Staff Report & Recommendation

Historic Preservation Board

SUBJECT: HPB19-0345, **901 & 927 Lincoln Road.**

An application has been filed requesting a Certificate of Appropriateness for the substantial demolition of the rear building and the construction of an attached rear addition as part of a new hotel development, one or more waivers and a variance to reduce the required rear setback.

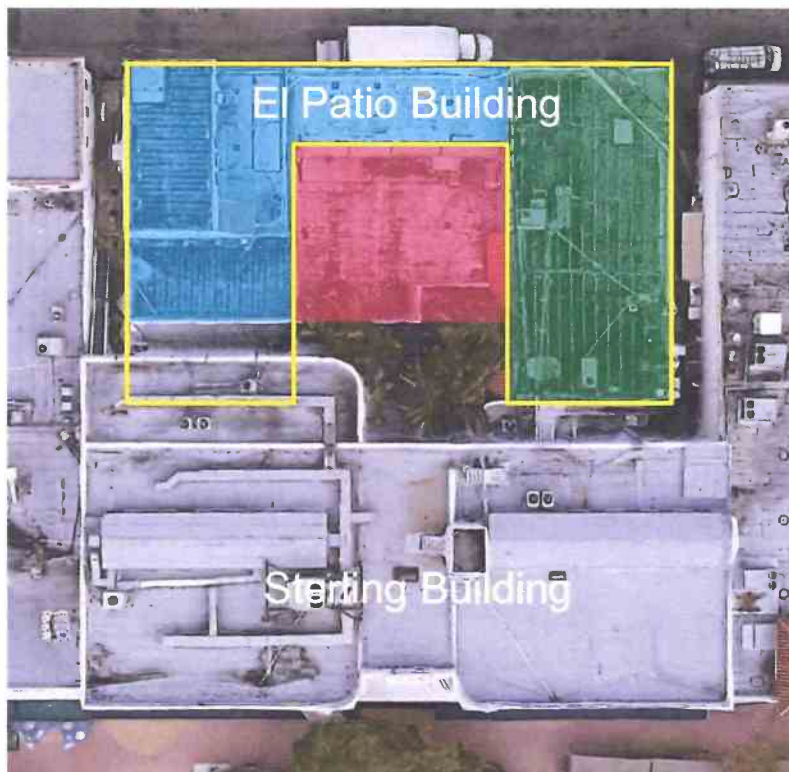
In 1955, an addition to the El Patio Building was constructed within the courtyard. This addition obscured much of the original rear structure with the exception of a small portion on the east side which remains visible today. The site was renovated in 1985 and has remained relatively the same since with the exception of the introduction of new awnings along the Lincoln road façade.
